Liberty School District – Storm Shelter Additions
Addendum No: 005
Description Narrative
October 06, 2023

Revised architectural sheets G102, A101A, A121A, A141, A332, A662

| F1 | Scale | Ceiling Detail - Lobby A102 |

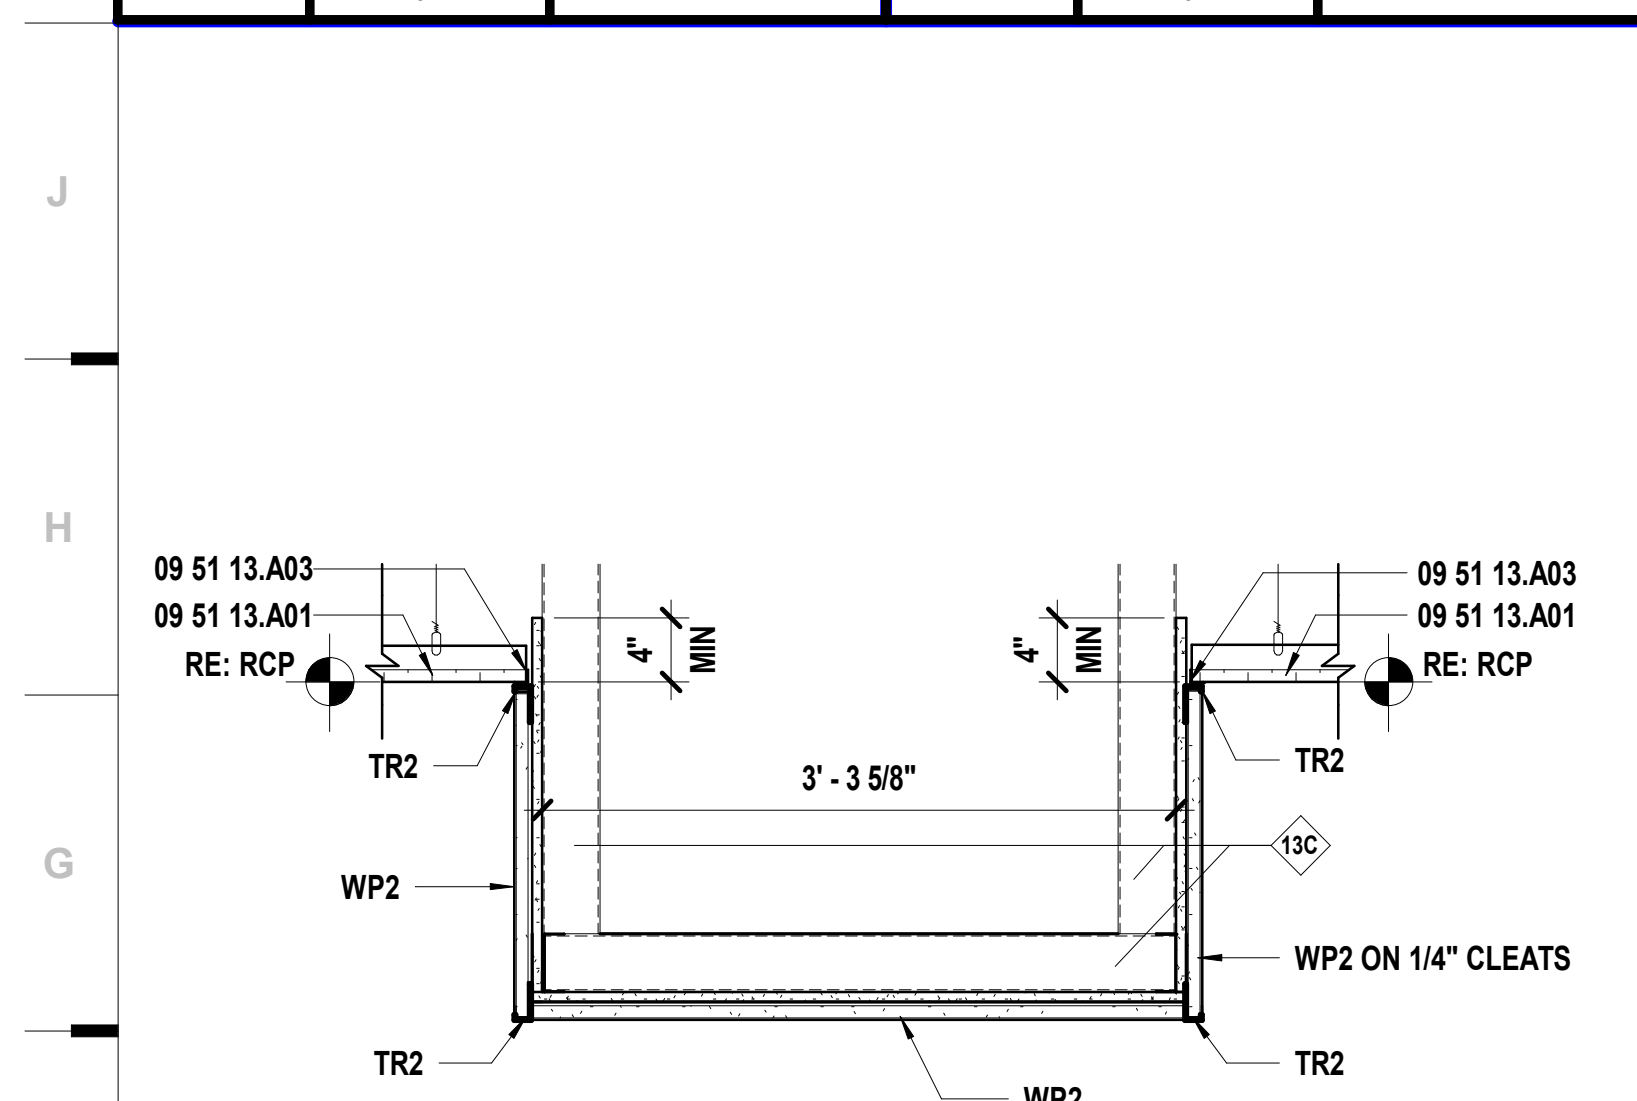
A8.3 REVISED detail A1 and F1, per sheet A121A.

| A1 | Scale | Ceiling Detail - |

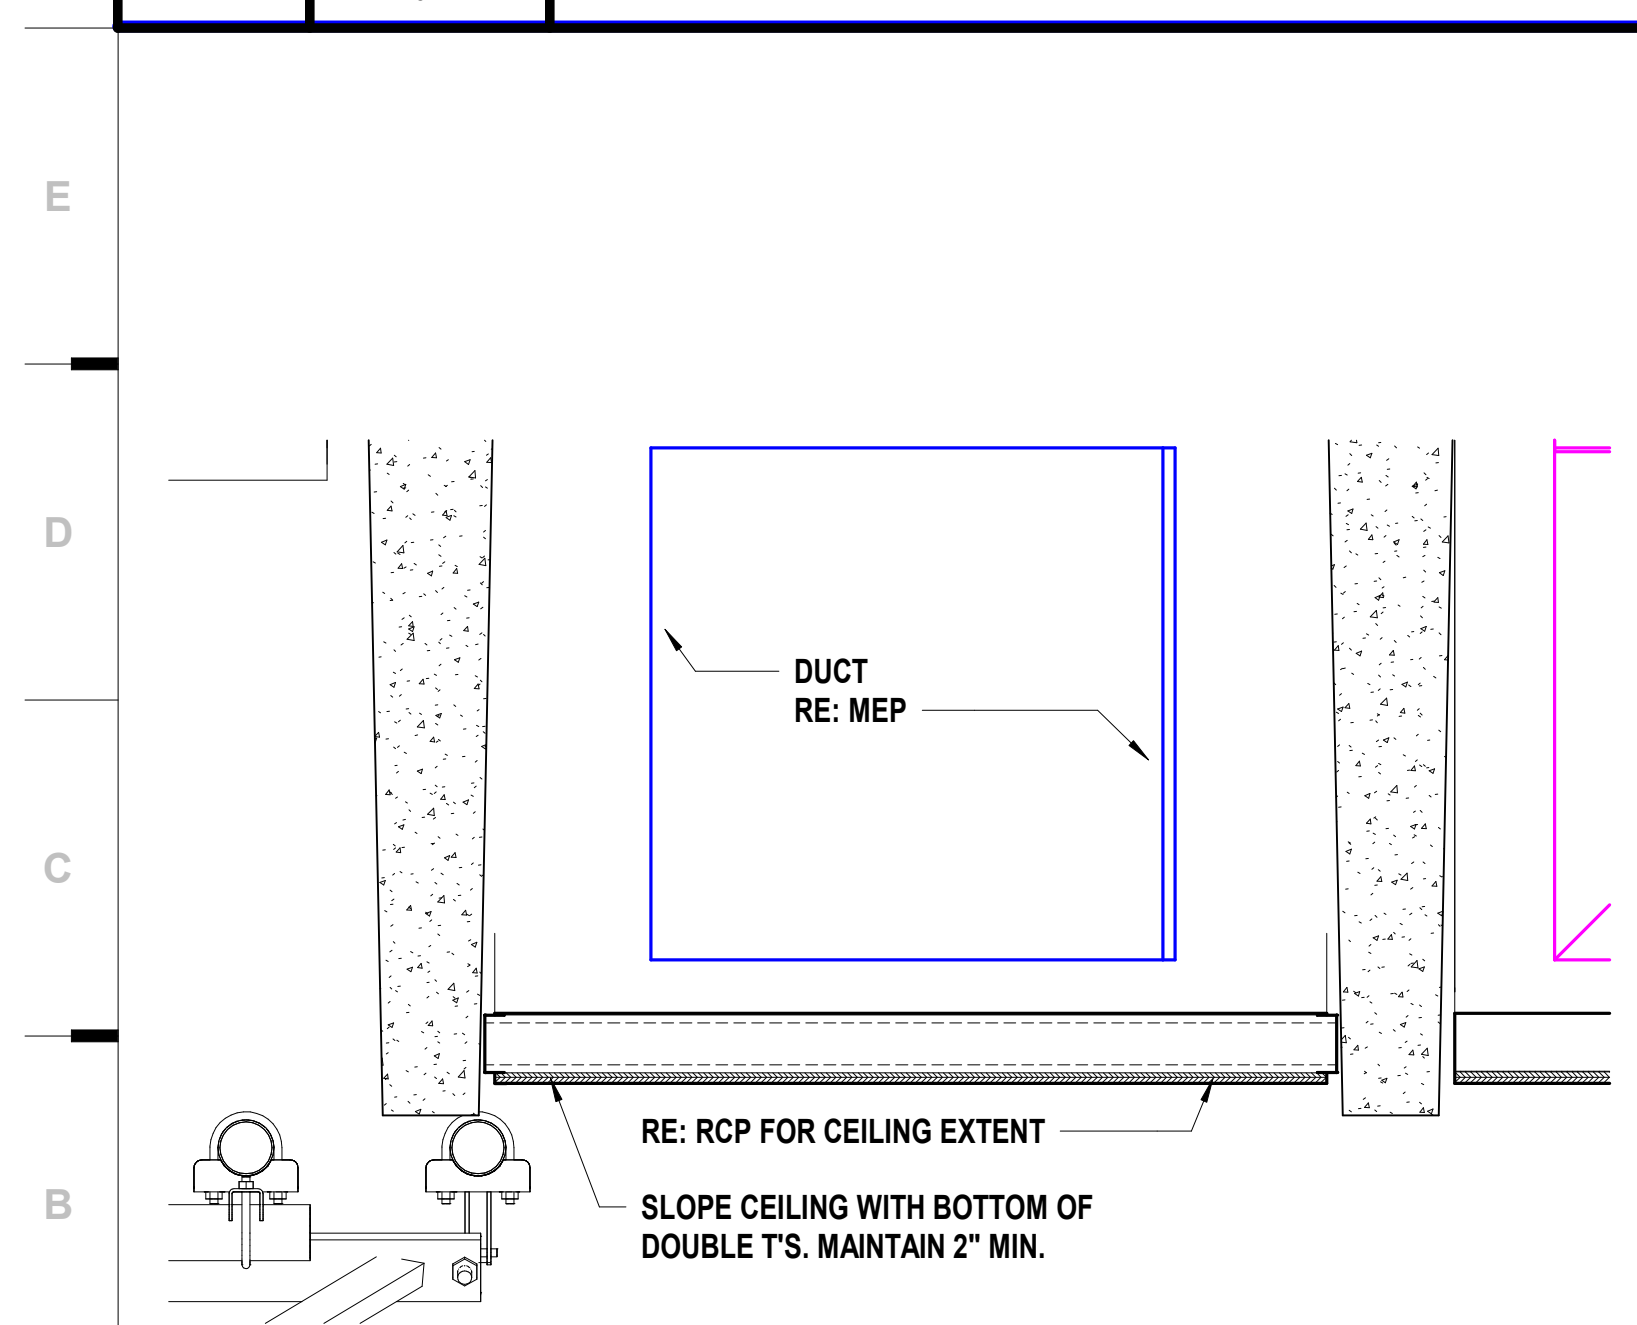
A14.3 RENUMBER detail 1 to A1 and REVISED, per sheet A121A.

| A5 | Scale | Reflected Ceiling Plan - Level 1 - Area A |

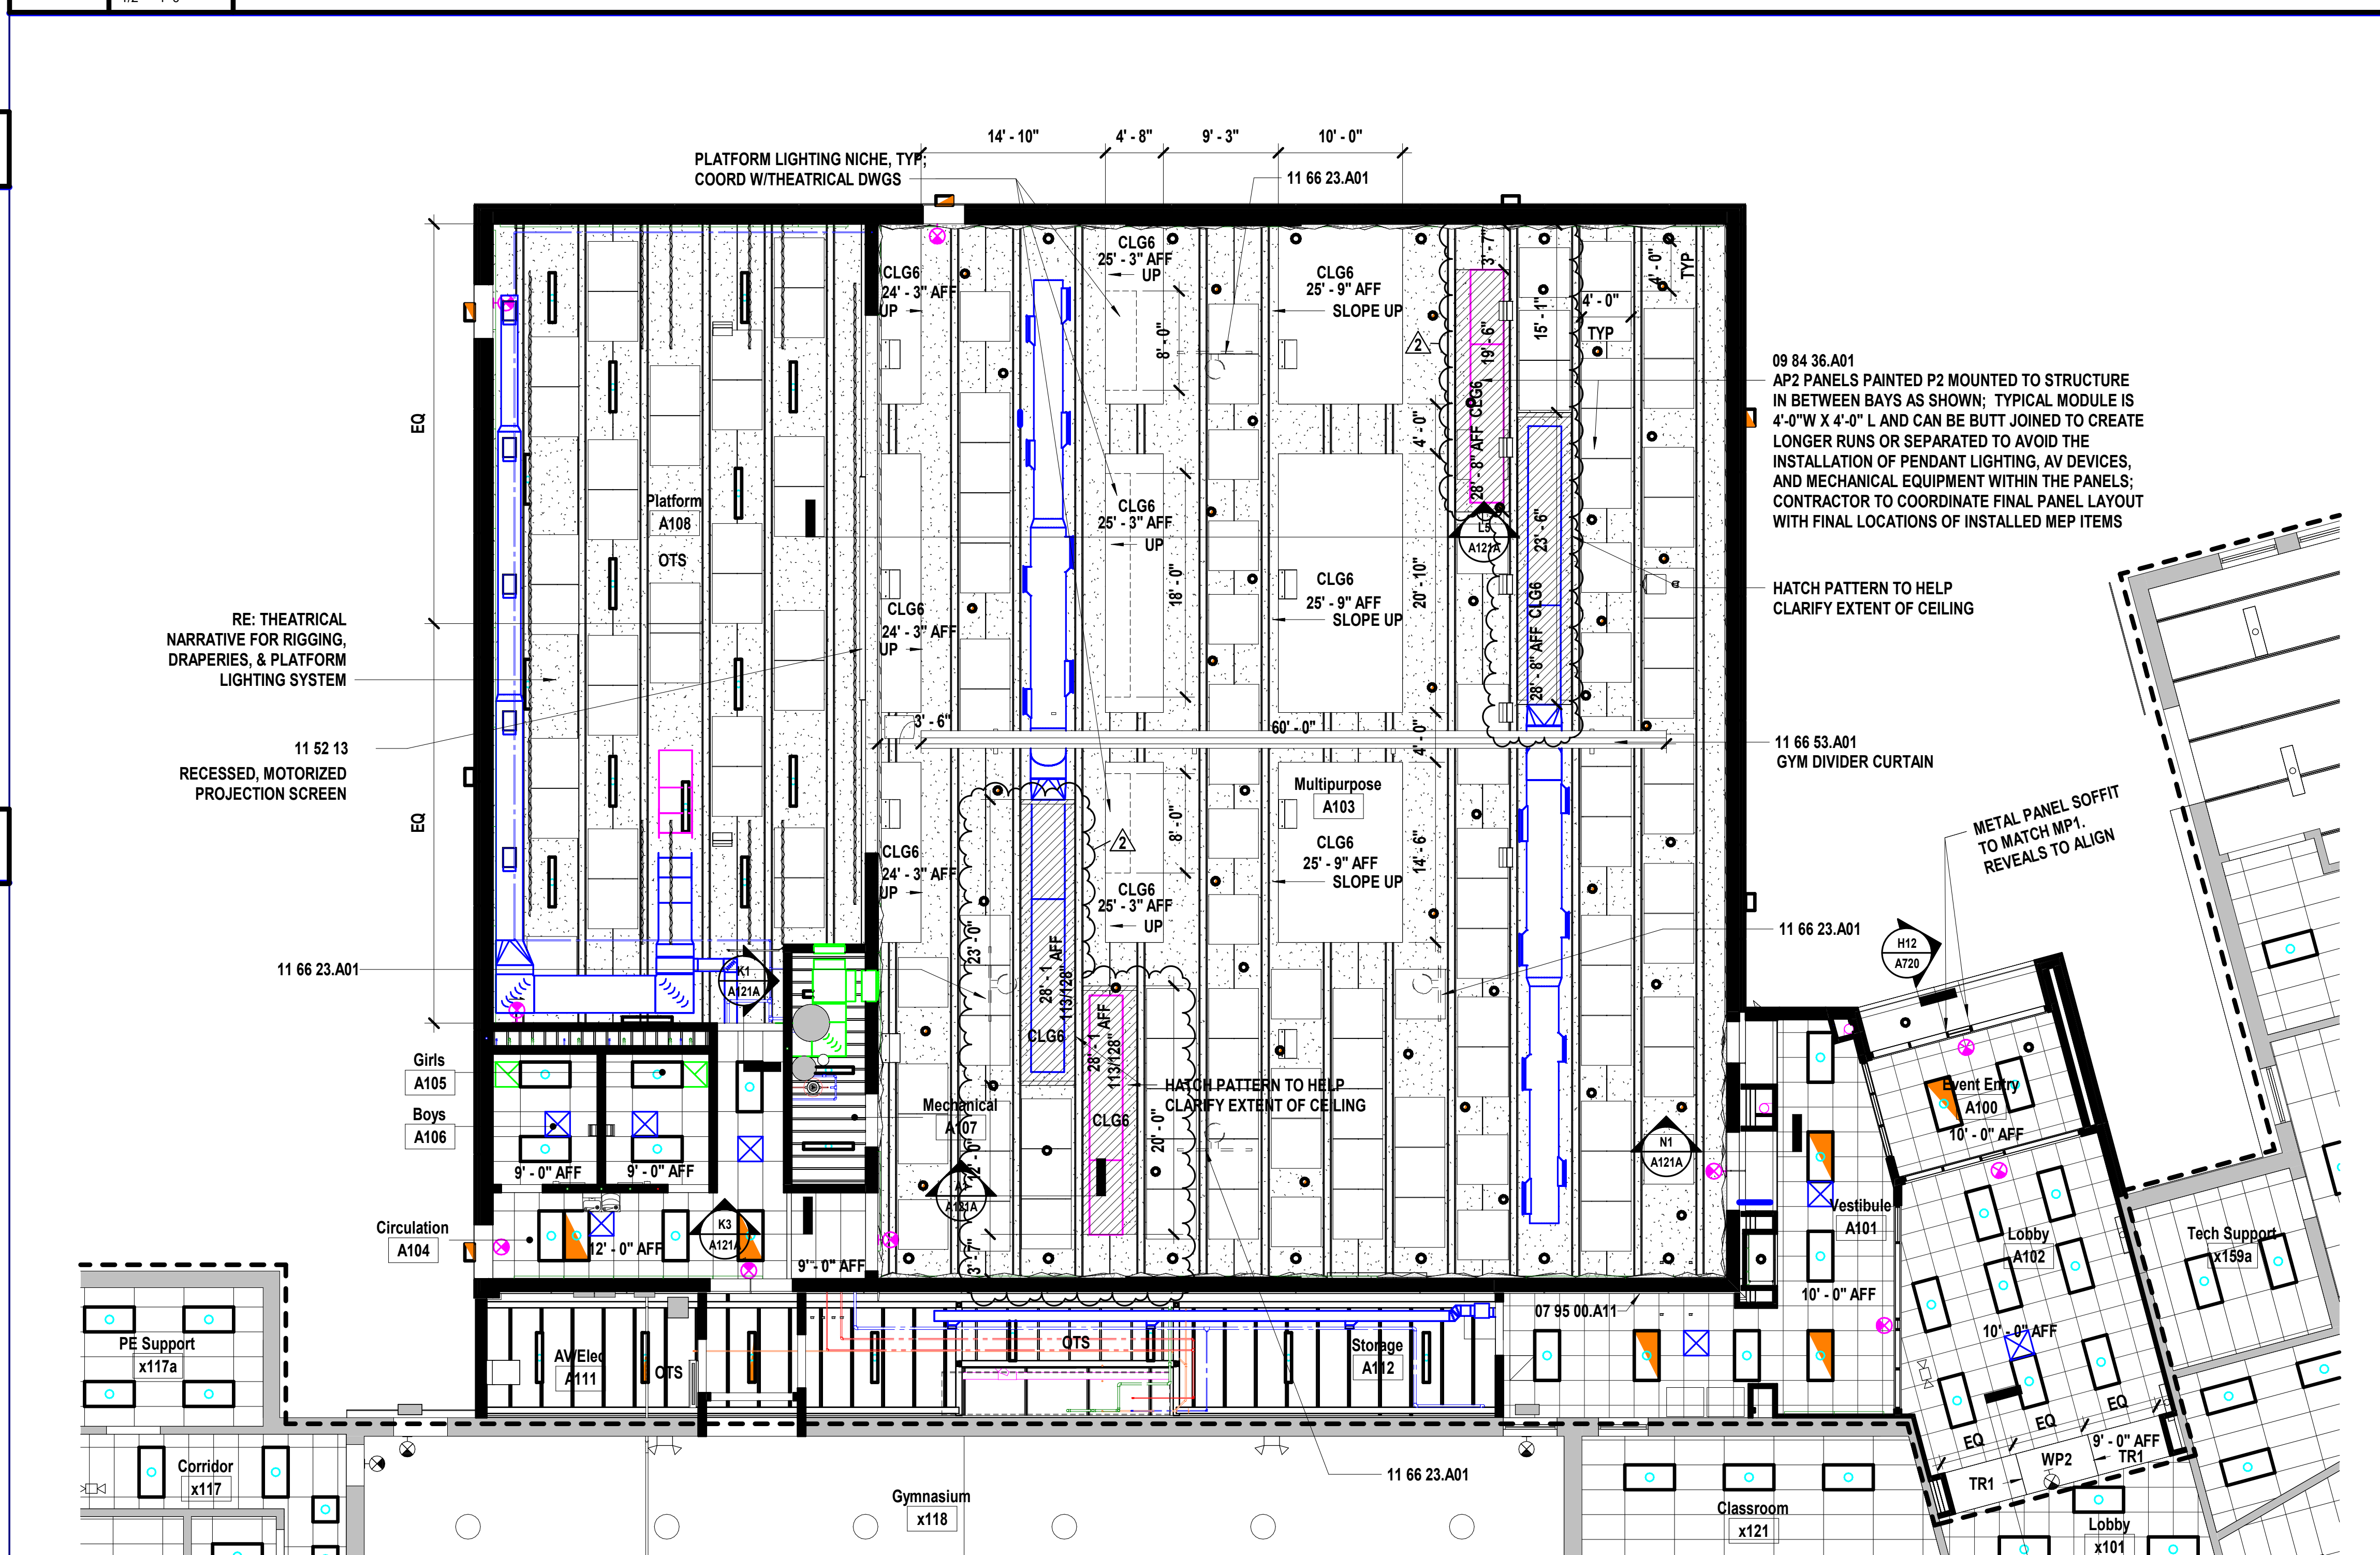
A8.2 REVISED ceiling in A5 to reflect RTU UPDATE, per sheet A121A.

Roof Plan

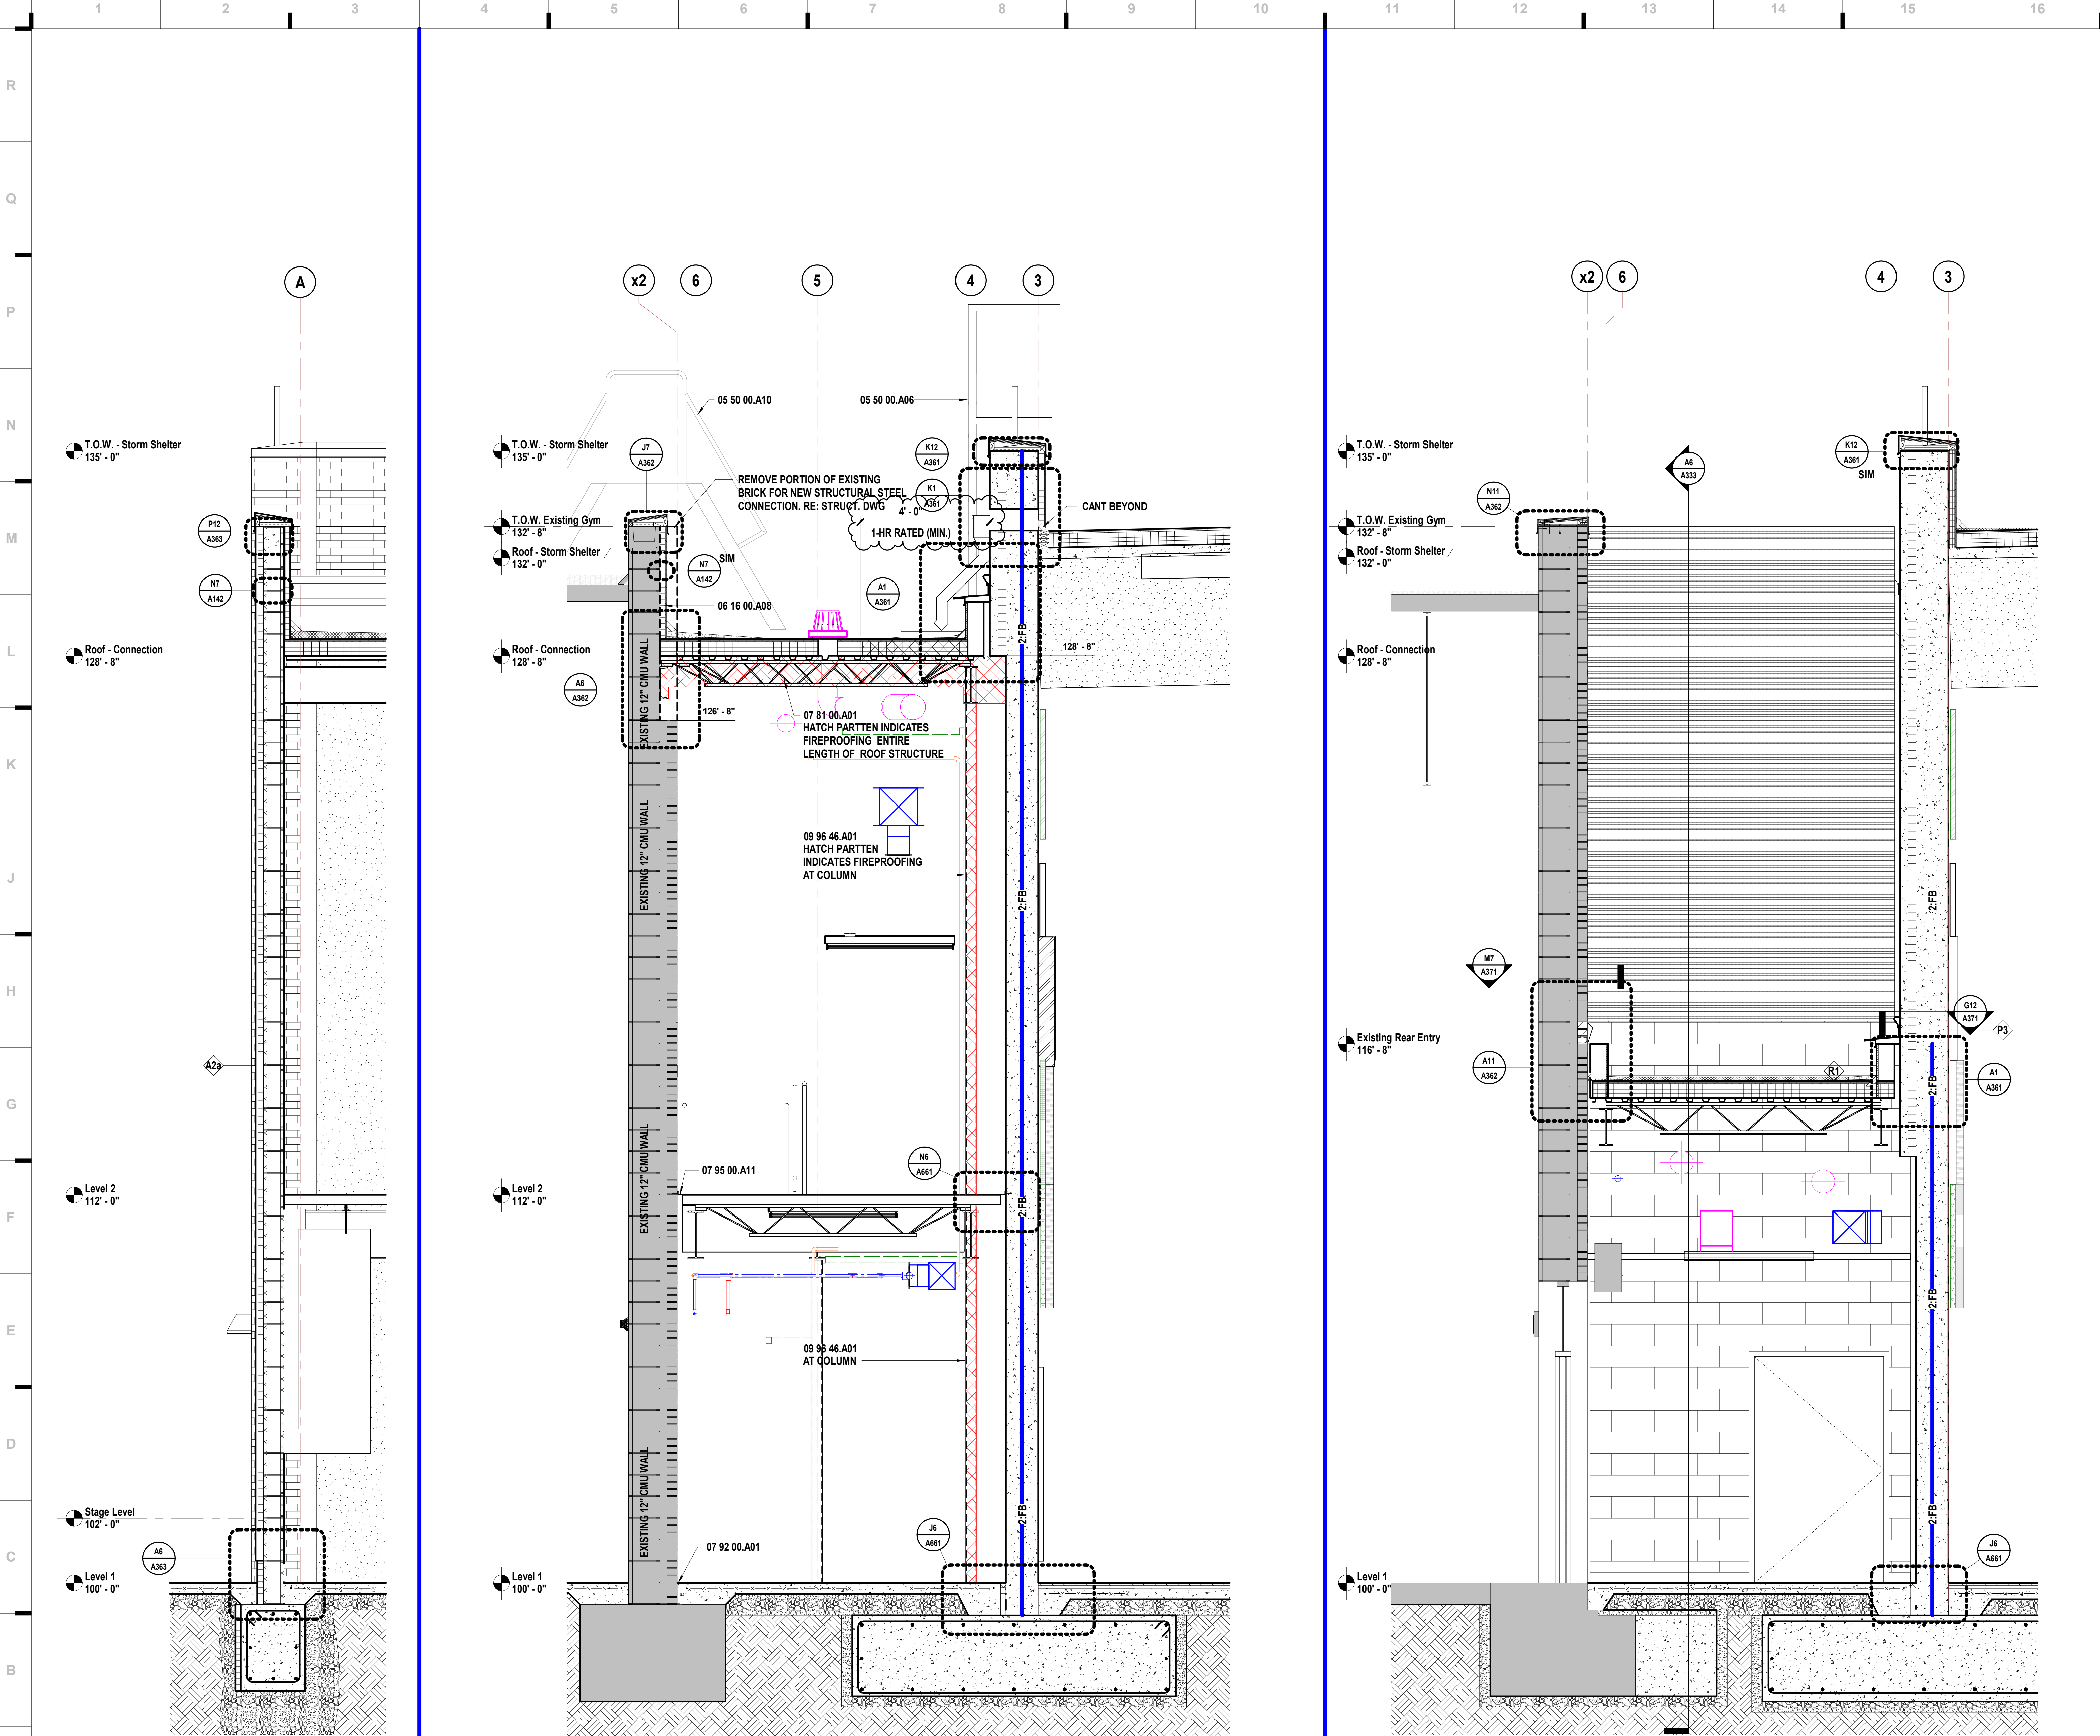
A9.1 REVISED walking pads and crickets to reflect RTU UPDATE, per sheet A141.
